CITY OF ST. HELENS PLANNING DEPARTMENT
STAFF REPORT
Conditional Use Permit CUP.1.24

DATE: December 2, 2024
TO: Planning Commission
FROM: Jacob A. Graichen, AICP, City Planner

ZONING: General Commercial, GC
LOCATION: 58646 McNulty Way
PROPOSAL: Construct new building for office, intermediate care facility, residential facility, detoxification center and crisis center uses and associated private and public improvements on the existing Columbia Community Mental Health (CCMH) campus

FIGURE 1-3: EXISTING SYSTEM EVALUATION - D/D AND POTENTIAL OVERFLOW LOCATIONS

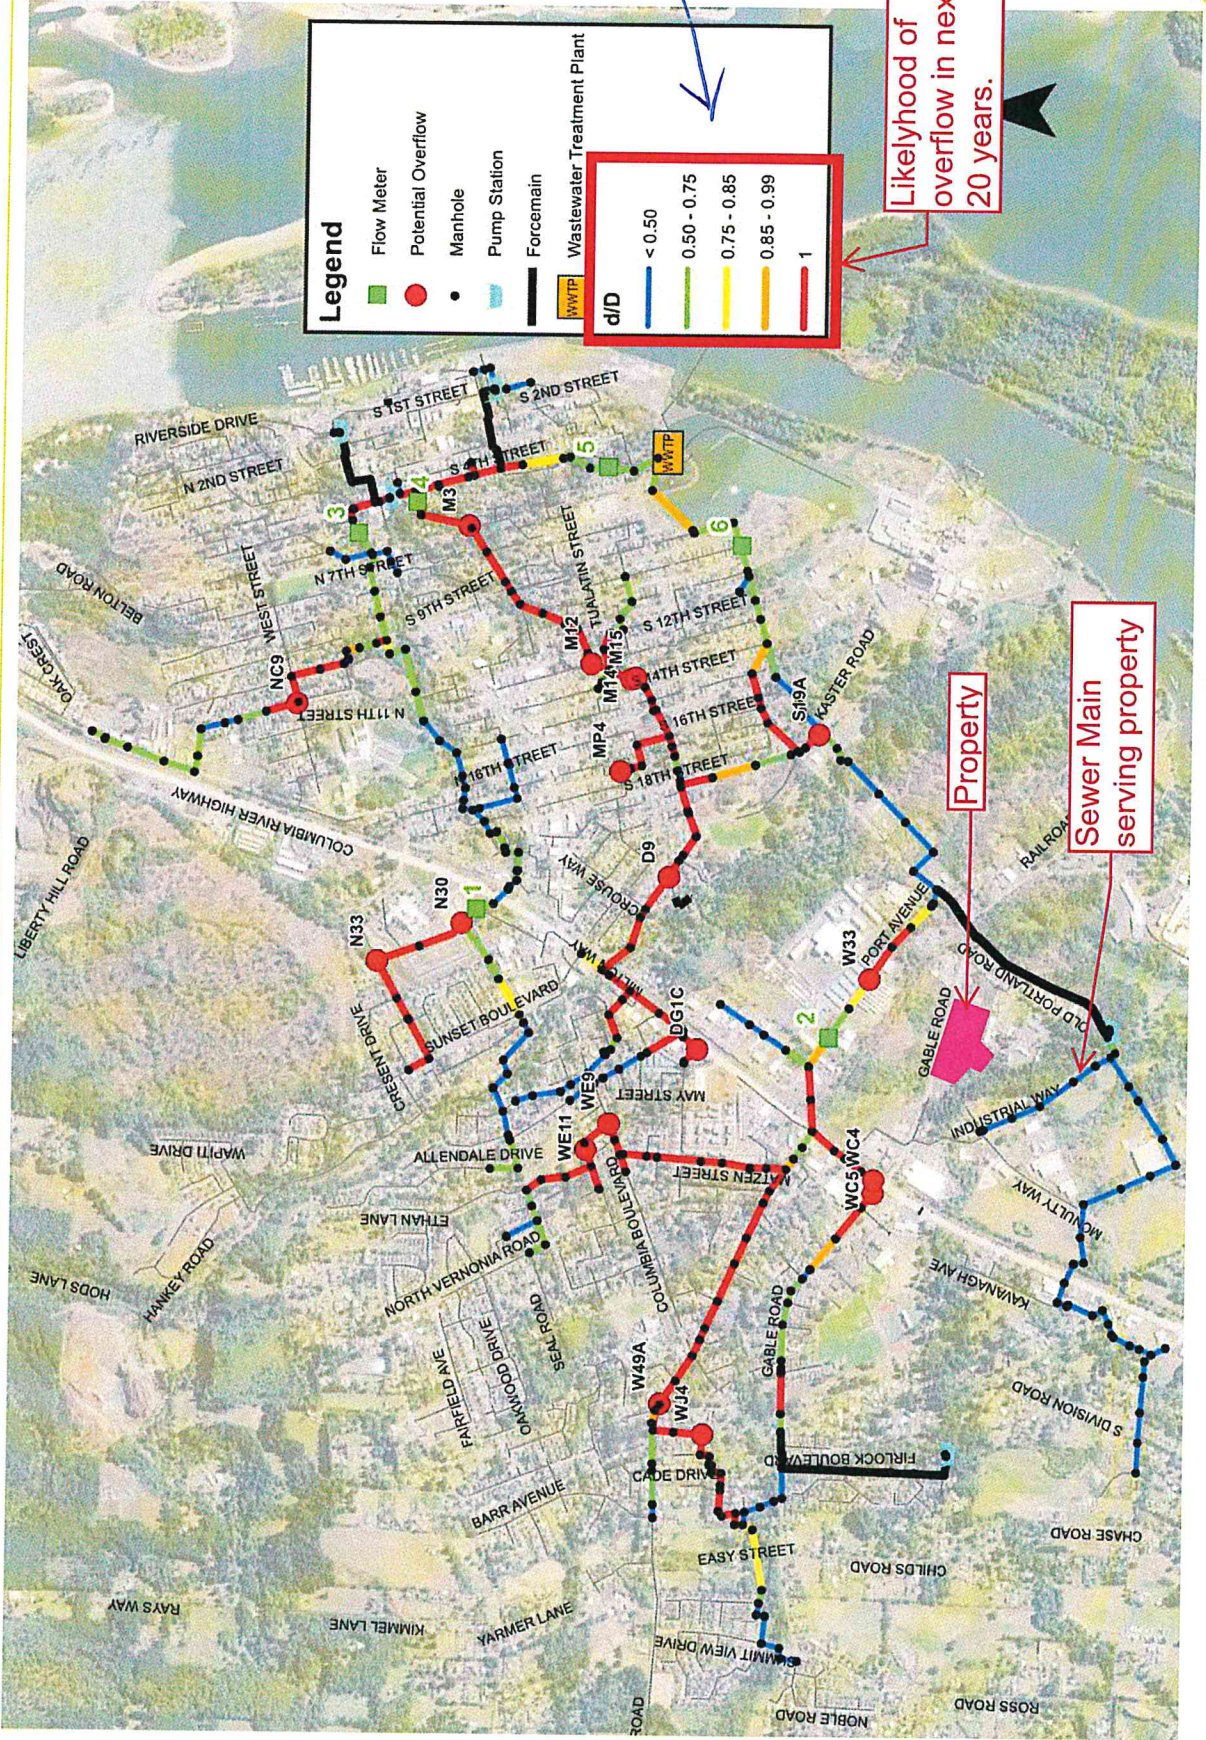
FIGURE 1-3 ON THE NEXT PAGE IS EXISTING -

NOT
20-YEAR

EXISTING - NOT 20 YEAR

CONTENTS:
 PHASE 1 & 2
 SITE PLAN

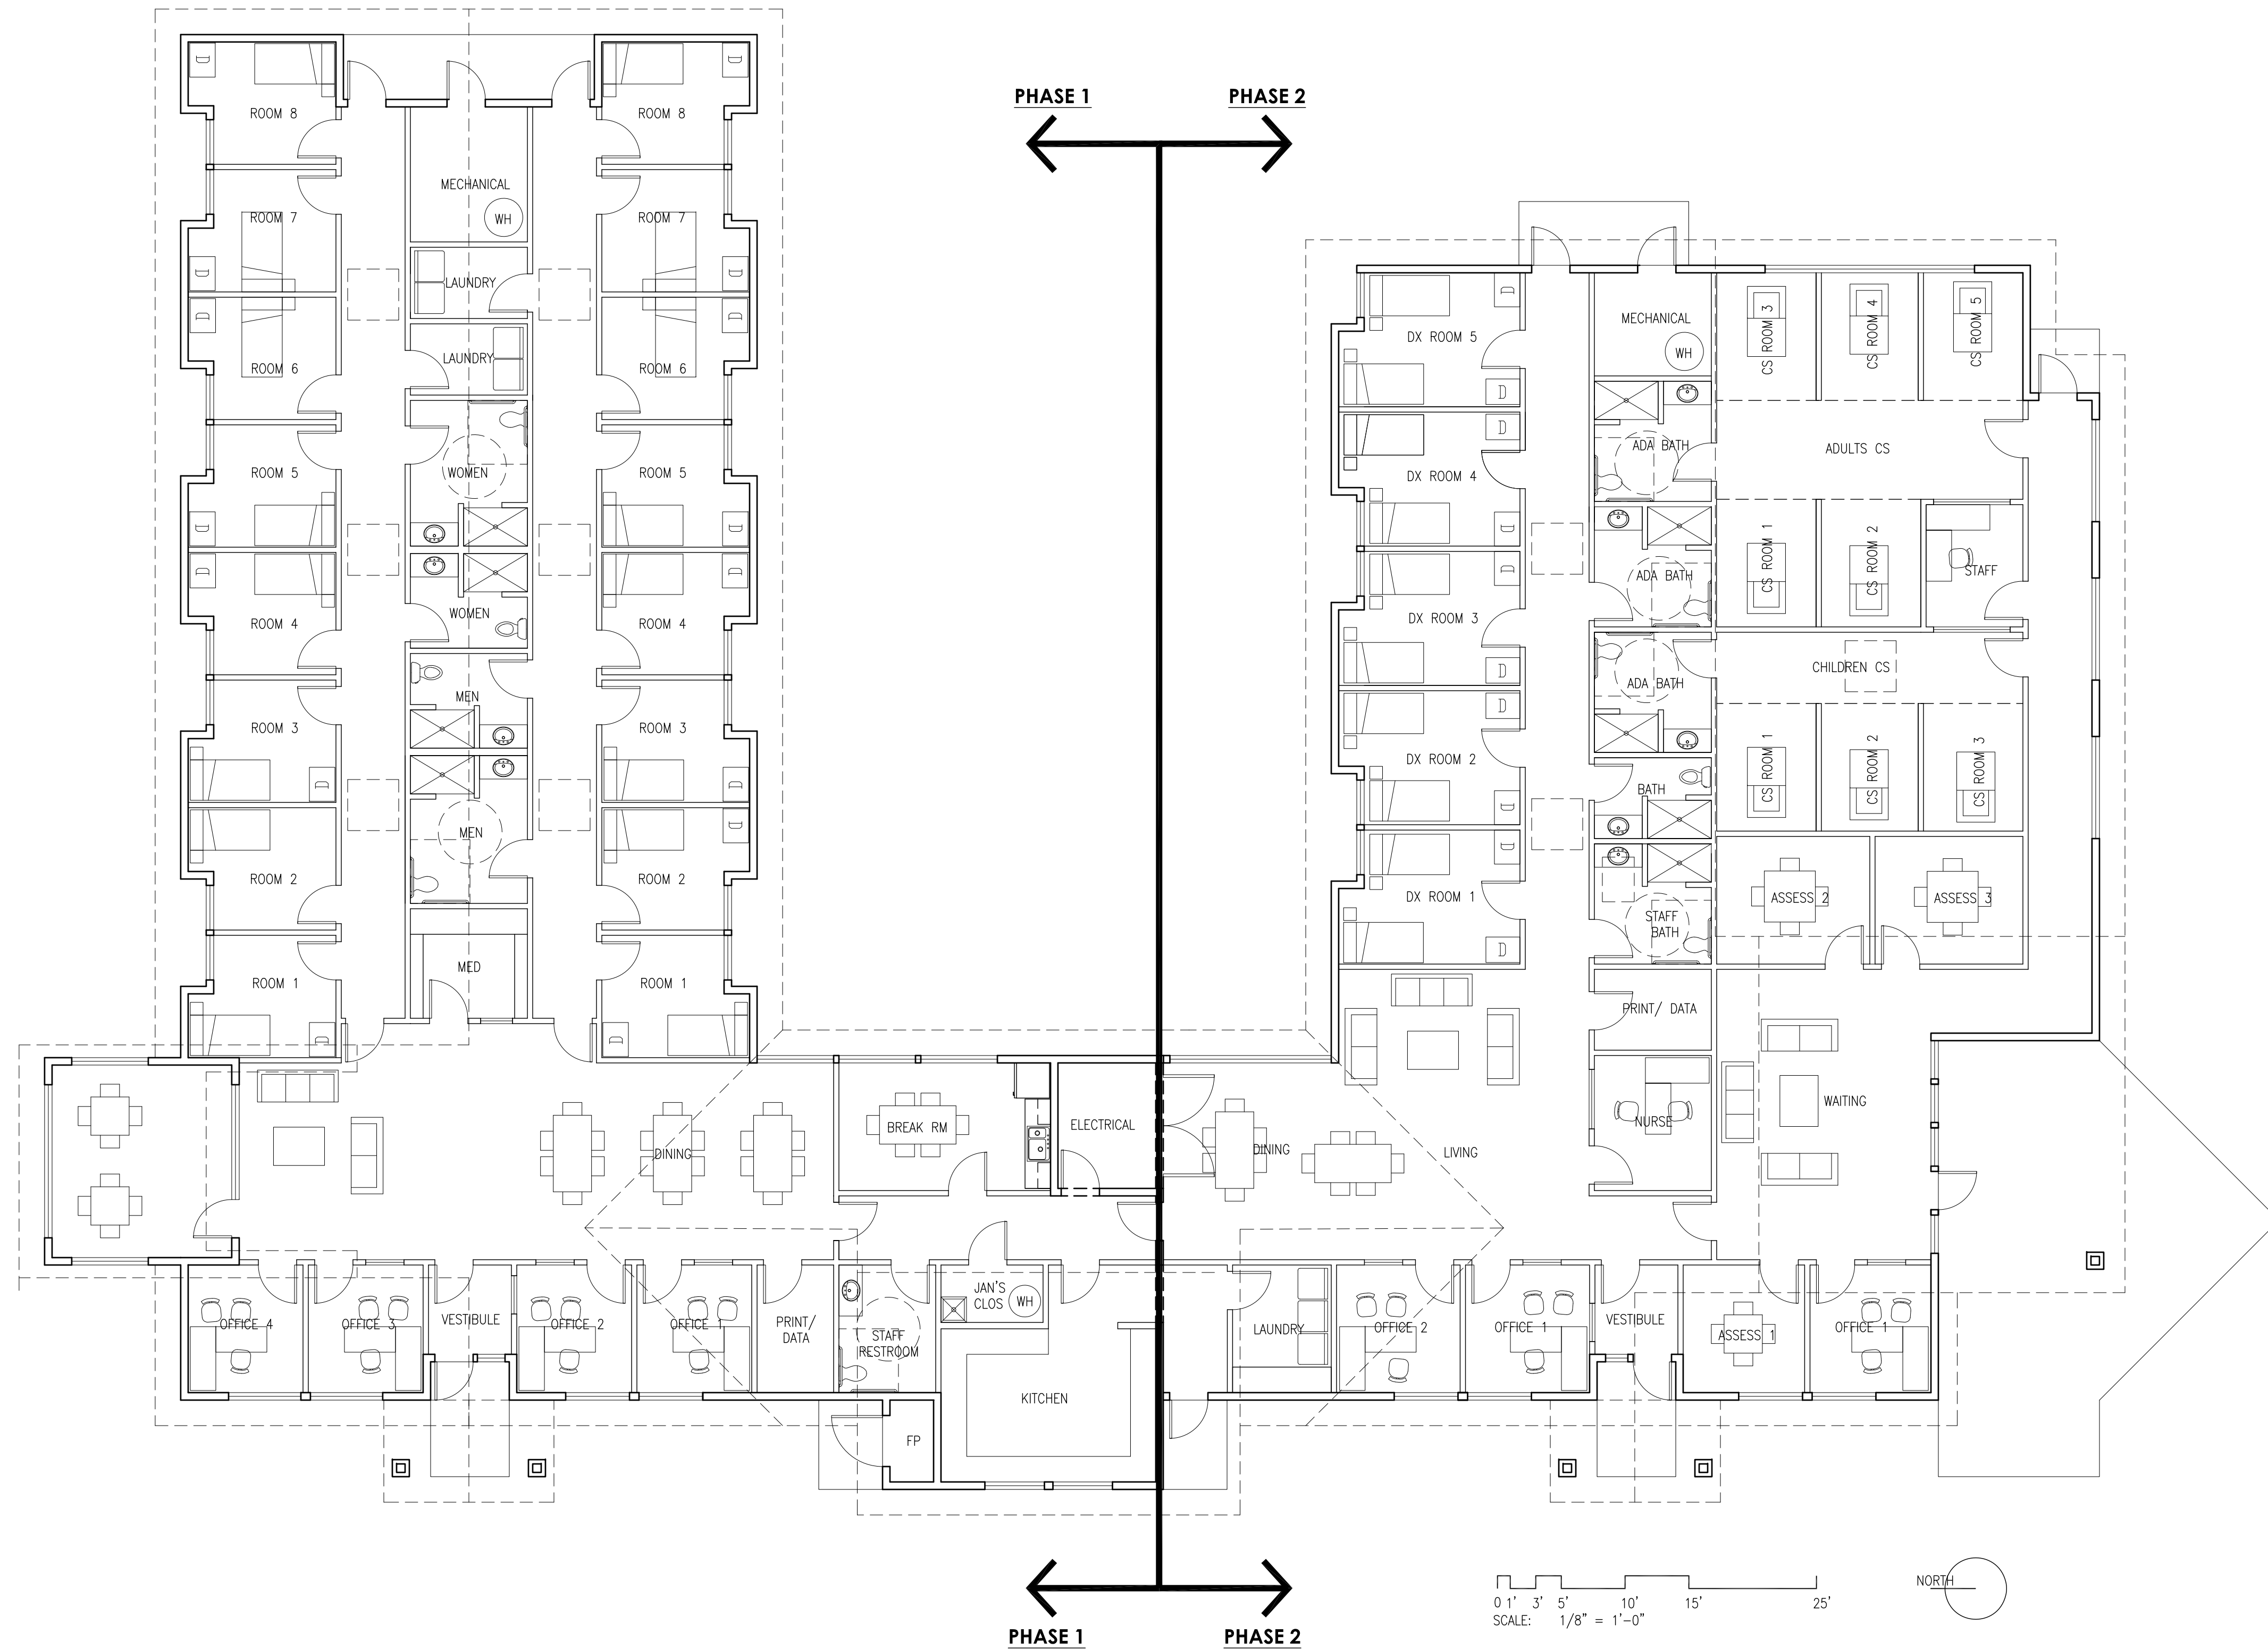
This is shown on the existing conditions but is inconsistent on the plans (e.g., absent on sheet SP-1). This detail will be required on all final plans.

- ii. As per condition 4.
 - iii. Refuse collection area in accordance with the applicable provisions of Chapters 17.72 and 17.92 SHMC.
 - iv. There appears to be some discrepancy between existing spaces identified on the plans and those actually marked. Existing and proposed spaces shall be properly identified based on actual existing conditions. For example:

- (1) Three striped spaces including an accessible space in front of Building N are not existing parking spaces in this gravel area and this conflicts with the existing conditions plan sheet C0.50.

- (2) Two parallel spaces in front of Building H are not existing parking spaces. There is no evidence such marking existed. These are not identified on the existing conditions plan sheet C0.50.

- (3) There are three marked spaces in front of Building B. The site plan incorrectly identifies five existing spaces contrary to actual existing conditions and existing conditions plan sheet C0.50.

OVERALL LAYOUT AND PAVING PLAN
 SCALE: 1"=40'

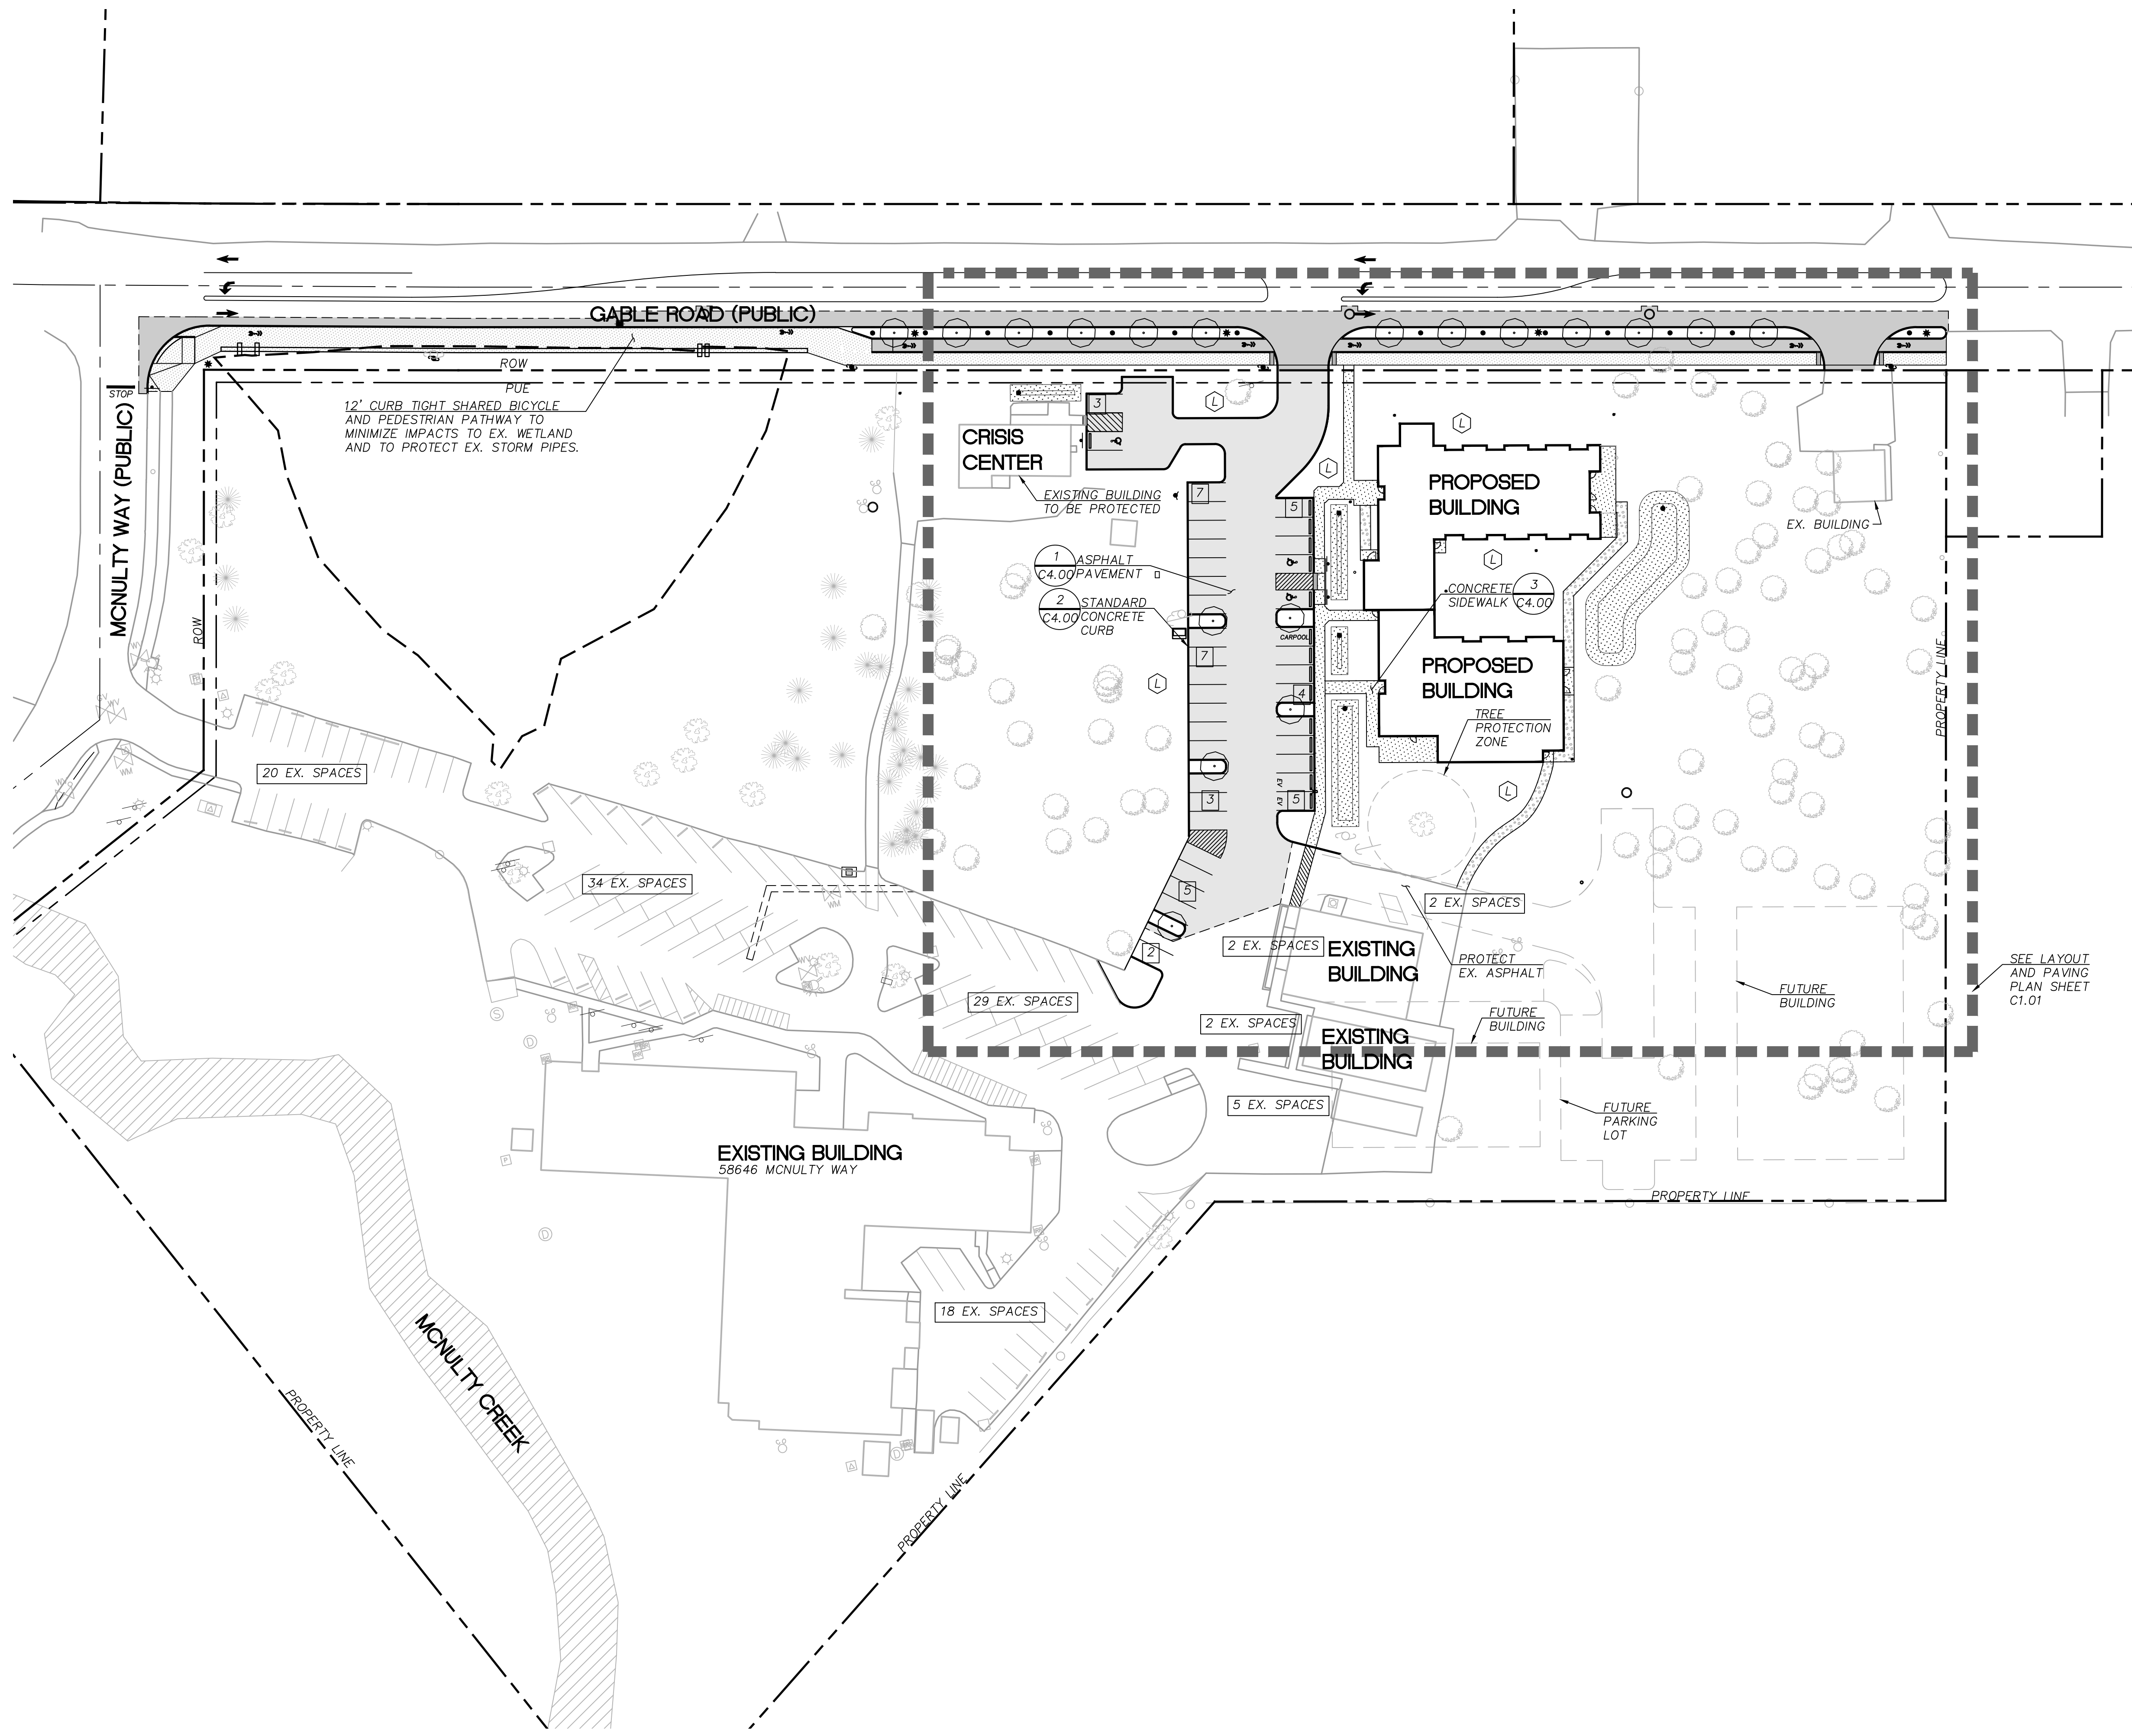
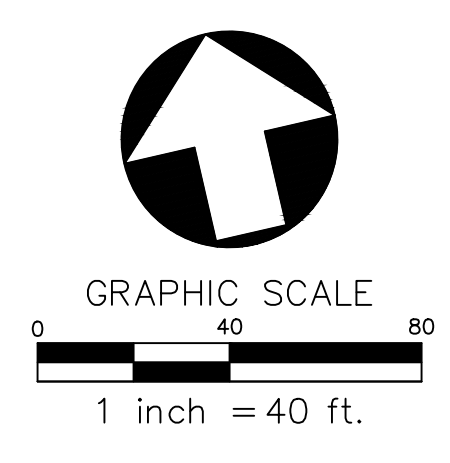
There appears to be some discrepancy between existing spaces identified on the plans and those actually marked. Spaces that are not designated shall not be included on the plans and count towards the final parking county unless they are proposed to be marked and do not conflict with past approvals. But this number of spaces is not anticipated to reduce the total amount below the minimum required.

Left: Photo taken September 27, 2024 of the modular buildings south of the proposed building. Parking spaces as striped (or not striped such as the parallel spaces) conflict with the plans provided. This conflict continued on updated plans received November 6, 2024. Existing and proposed spaces need to be properly identified. The parallel spaces in front of Building H are not marked and if intended to be should be identified as *proposed*. Also, there are three marked spaces in front of Building B whose length is perpendicular to the front of the building as opposed to being five existing spaces parallel with the front of the building as indicated on the plans.
